TELEVISION TECHNICAL BULLETIN

<u>MODELS</u>	51CS03H	51CS03IR	51CS05H	59CS03H
	59CS03IR	59CS05H	59CSD8H	66CS03H
	66CS03IR	66CS05H	66CSD8H

Reference UK92300X

FIG 1

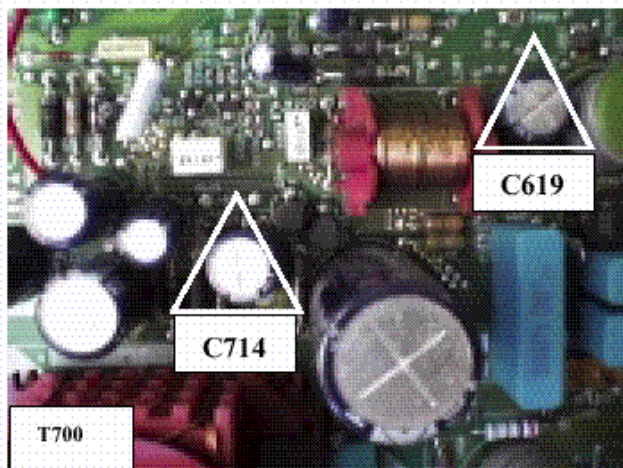
Failure of C604, C619 and/or C714.

Replace the capacitors with high temperature types.
